# Access Compliance Report Public Rights-of-Way (Curb Ramps)

Main Street: N\_PAMPAS\_ST Cross Street: LINCOLN\_AVE Location: SW

ADA ID: RPAT210924085207 Ramp Type: Type 1 - Perpendicular Diagonal Initial Pass/Fail: Pass Overall Compliance: No Severity Score: 0

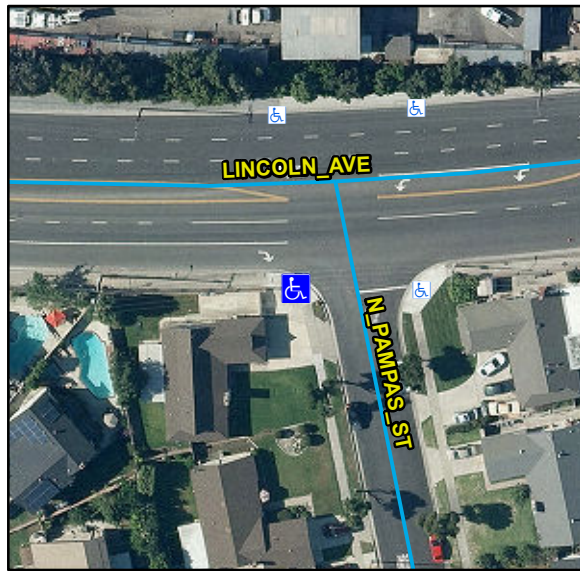
| Compliance | Description                           | Data | Compliance | Description                   | Data   |
|------------|---------------------------------------|------|------------|-------------------------------|--------|
| Yes        | Gutter Ponding                        | No   | No         | Curb Slope                    | 5.9    |
| No         | Gutter Cross Slope (%)                | 2.9  |            |                               |        |

Remove & Replace Curb Ramp With Two New Directional Ramps or Equivalent. Remove & Replace Gutter.
